## NORTHERN FENCE MODIFICATIONS

Marshall Day Acoustics have previously prepared an acoustic assessment of the proposed West Ryde Multi Sports Facility, detailed in the Acoustic DA report prepared by MDA and identified as Rp 002 r03 20210967 (dated 23 March 2023) with addendum letter Lt 001 r01 20210967 (dated 27 July 2023). This letter should be read in conjunction with those documents.

**Figure 2: Northern barrier proposed alternative scheme**

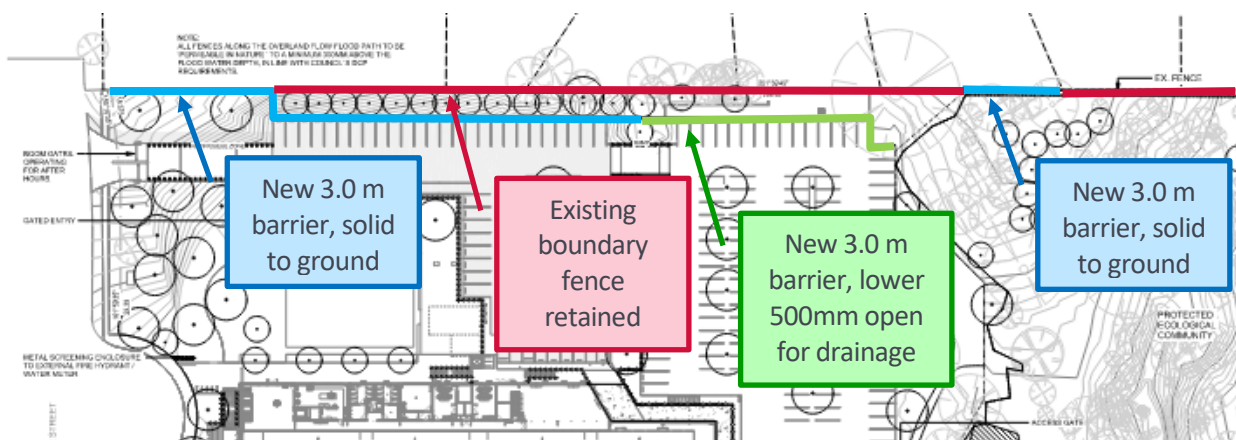
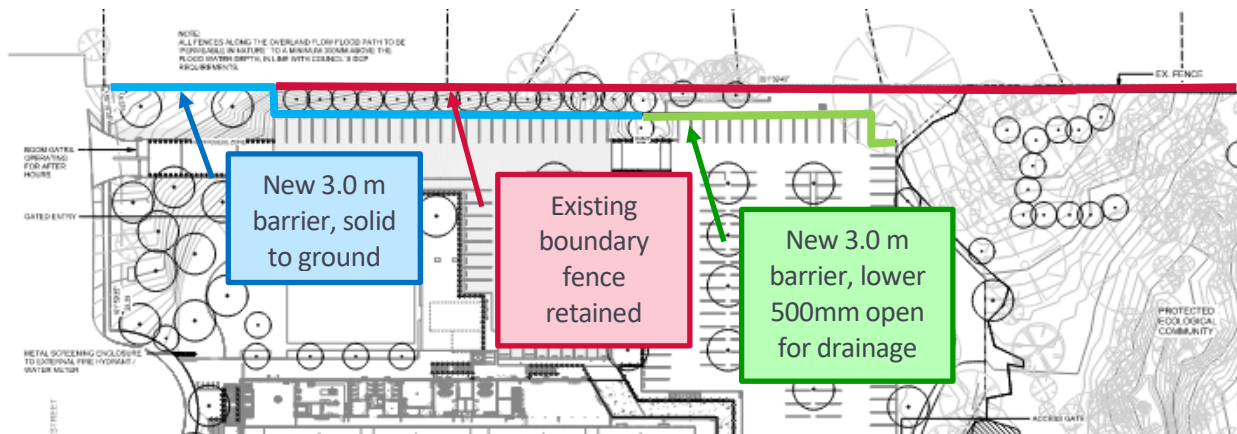
An alternative barrier scheme has been proposed for assessment, with the 3.0 m section of the boundary fence adjoining 4 Daphne Street reduced to 1.8m height, to match the existing fence height. This proposed layout is as show in Figure 2.

The sound pressure level contributions to the receiver identified as 3 Daphne Street in the report (which is the receiver on the boundary of 3 & 4 Daphne St) with the alternative fence design per Figure 2 are as follows (with changes referenced to the results in Lt 001 r01):

- Daytime operations of carpark and indoor courts noise levels (Table 12) increase from a cumulative 40 dB to 44 dB  $L_{Aeq(15min)}$ . This is 1 dB above the criteria of 43 dB. This is the same level of exceedance (1dB) as predicted for the receiver at 7 Daphne Street.
- Evening operations of carpark and indoor courts noise levels (Table 13) increase from a cumulative 34 dB to 39 dB  $L_{Aeq(15min)}$ . This is 3 dB below the criteria of 42 dB.
- Shoulder period restricted operations of carpark and indoor courts noise levels (Table 14) increase from a cumulative 24 dB to 30 dB  $L_{Aeq(15min)}$ . This is 8 dB below the criteria of 38 dB.
- Outdoor netball court noise levels (Table 15) increase from 40 dB to 47 dB  $L_{Aeq(15min)}$ .
